Addendum 128 – UN Regulation No. 129

Revision 4 - Amendment 2

Supplement 2 to the 03 series of amendments – Date of entry into force: 11 January 2020

Uniform provisions concerning the approval of Enhanced Child Restraint Systems used on board of motor vehicles

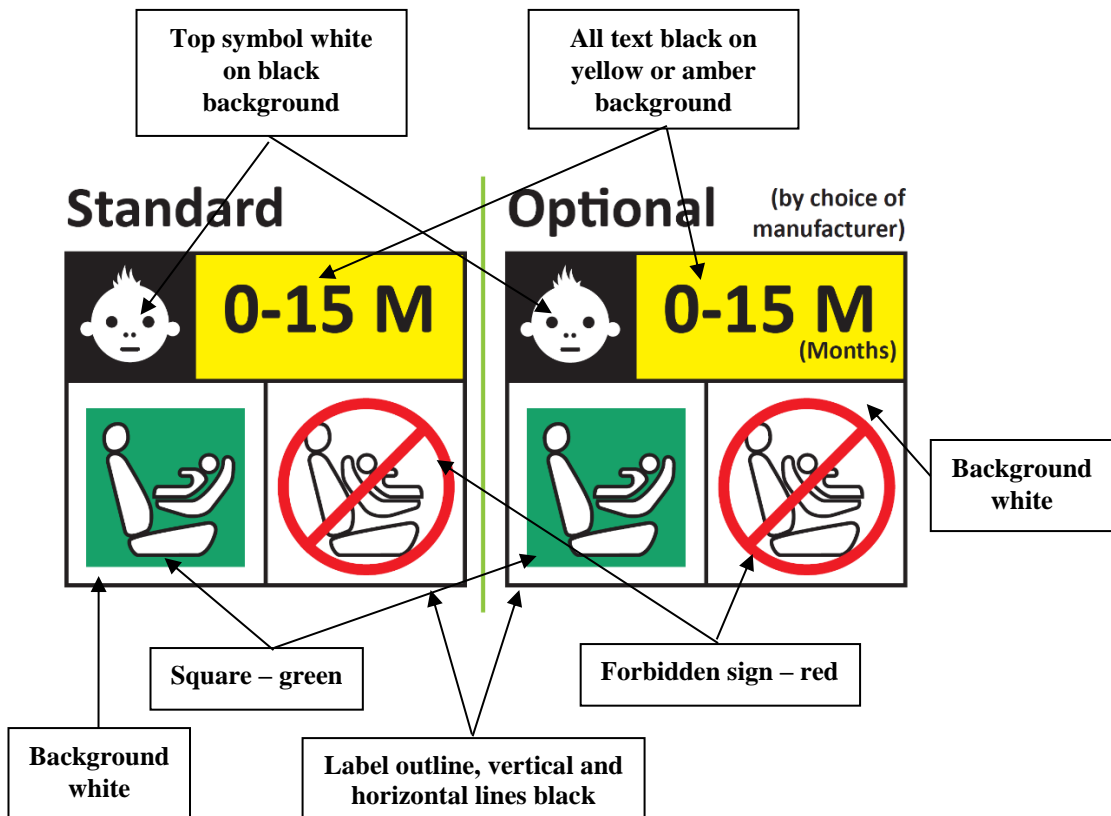
Paragraph 4.5., amend to read:

"4.5. Integral Enhanced Child Restraint Systems that can be used forward and rearward facing, shall have the following label permanently attached on the part hosting the child and visible to the person installing an Enhanced Child Restraint System in the vehicle:

The manufacturer shall be permitted to include the word "months" to explain the symbol "M" in the label. The word "months" should be in a language commonly spoken in the country or countries where the product is sold. More than one language is allowed.

Minimum label size 40 x 40 mm

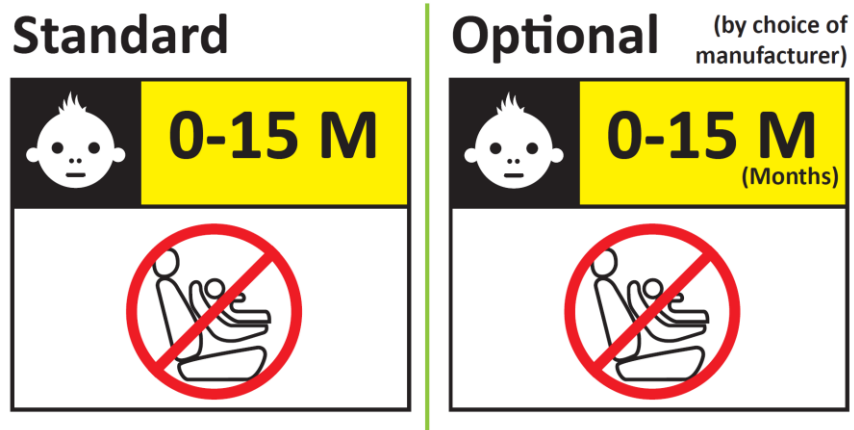
Integral Enhanced Child Restraint Systems that can be used forward facing only shall have the following label permanently attached on the part hosting the child and visible to the person installing an Enhanced Child Restraint System in the vehicle:

The manufacturer shall be permitted to include the word "months" to explain the symbol "M" in the label. The word "months" should be in a language

commonly spoken in the country or countries where the product is sold. More than one language is allowed.

Minimum label size 40 x 40 mm

Figure 1
Arrangement for testing a forward-facing device

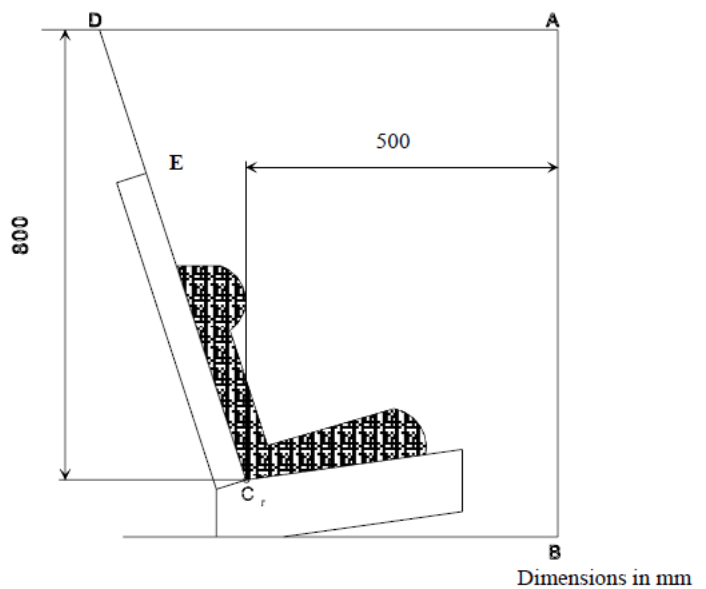
Paragraphs 6.6.4.4.1.1. and 6.6.4.4.1.1.1., amend to read:

"6.6.4.4.1.1. Forward facing Enhanced Child Restraint Systems

Head excursion: No part of the head of the dummy shall pass beyond the planes BA, DA and DE as defined in Figure 1 below. However, the head of the dummy may pass beyond the DE plane, if there is part of the child restraint structure, i.e. head pad or backrest, behind the head of the dummy, at the point the head passes the DE plane.

This shall be judged up to 300 ms or the moment that the dummy has come to a definitive standstill whatever occurs first.

Except for booster seats when testing using Q10 dummy where:

- (a) The value in relation to the DA plane is 840 mm; and
- (b) The value in relation to the BA plane is 550 mm; and

- (c) The rebound phase is not considered for the assessment of the plane DA and DE.

6.6.4.4.1.1.1. Where a test is conducted in accordance with paragraph 6.6.4.1.6.2. or paragraph 6.6.4.1.8.2. above, a tolerance of +10 per cent shall be applicable to the head excursion value distance between Cr point and plane AB.

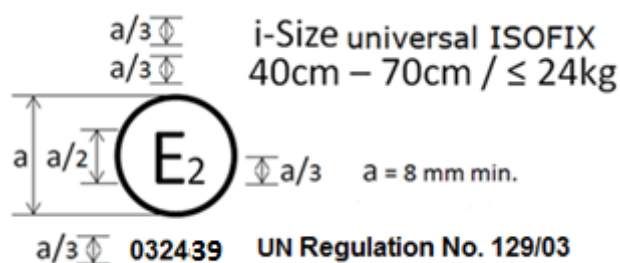
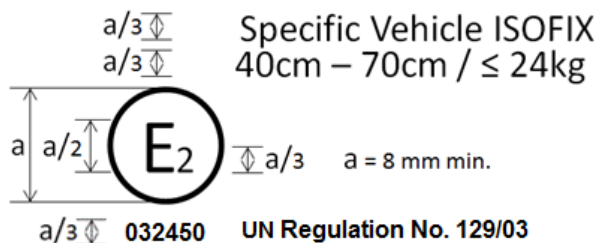
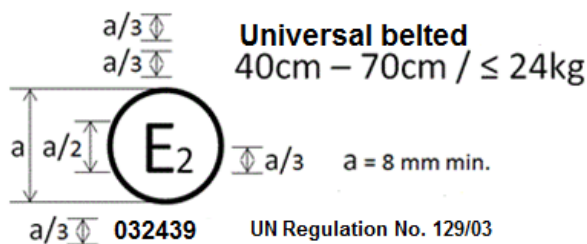
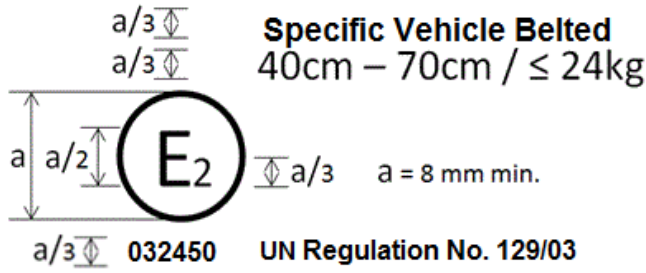
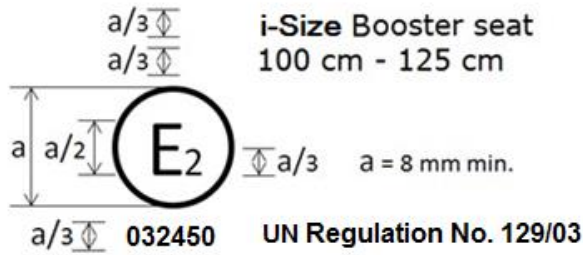
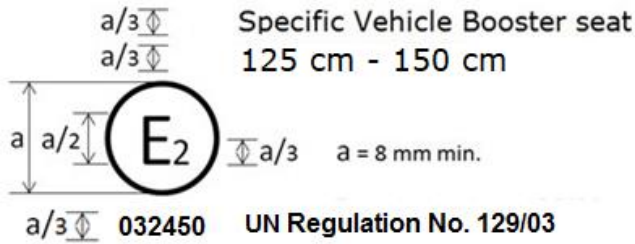
Annex 2., the example of approval markings only, amend to read:
